Access Compliance Report

Public Rights-of-Way

(Curb Ramps)

Intersection ID: 5741	Main Street: MALLARD_CREEK_RD	Cross Street: NEVIN_RD	Location:	N
ADA ID: C6752FA59F83	Ramp Type: Perp	Initial Pass/Fail: Fail	Overall Compliance: No	Severity Score: 8.75

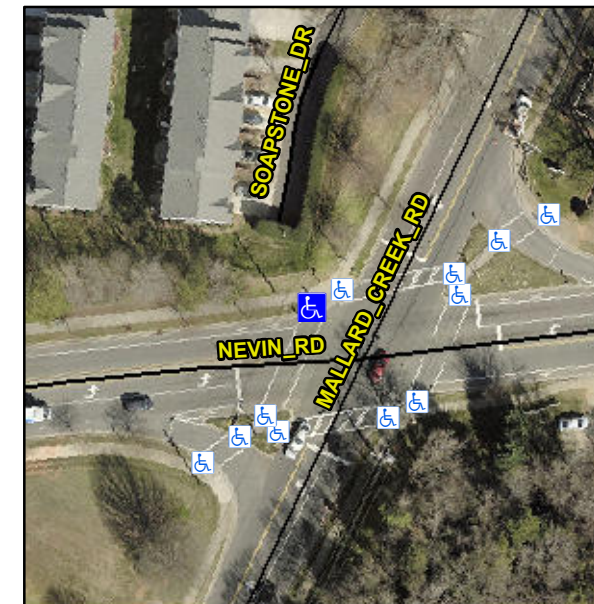
Not Found, R304.5.1

Compliance	Description	Data	Compliance	Description	Data
N/A	Ramp Length (in)	60.0	Yes	Ramp Slope (%)	5.2
No	Ramp Width (in)	47.5	Yes	Ramp XSlope (%)	1.9
N/A	Flare Type LT	N/A	N/A	Flare Type RT	N/A
N/A	Flare Slope LT (%)	N/A	N/A	Flare Slope RT (%)	N/A
N/A	Flare Traversable LT?	N/A	N/A	Flare Traversable RT?	N/A
N/A	Landing Length (in)	N/A	N/A	DWS Provided?	N/A
N/A	Landing Width (in)	N/A	N/A	DWS Contrast?	N/A
N/A	Landing Slope (%)	N/A	N/A	DWS Length (in)	N/A
N/A	Landing X Slope (%)	N/A	N/A	DWS Full Width?	N/A
N/A	Landing Curb? (Y/N)	N/A	N/A	DWS Offset (in)	N/A
N/A	Shared Landing?	N/A			
N/A	Gutter Ponding?	N/A	N/A	Gutter Slope (%)	N/A
N/A	Gutter Lip Ht (in)	N/A	N/A	Gutter X Slope (%)	N/A
N/A	Painted X Walk1?	Yes	N/A	Painted X Walk2?	N/A
	X Walk 1 Direction	To SW		X Walk 2 Direction	N/A
N/A	X Walk 1 Width (in)	120.0	N/A	X Walk 2 Width (in)	N/A
	X Walk 1 Slope (%)	0.9		X Walk 2 Slope (%)	N/A
	X Walk 1 X Slope (%)	1.2		X Walk 2 X Slope (%)	N/A

Remove & Replace Entire Ramp.
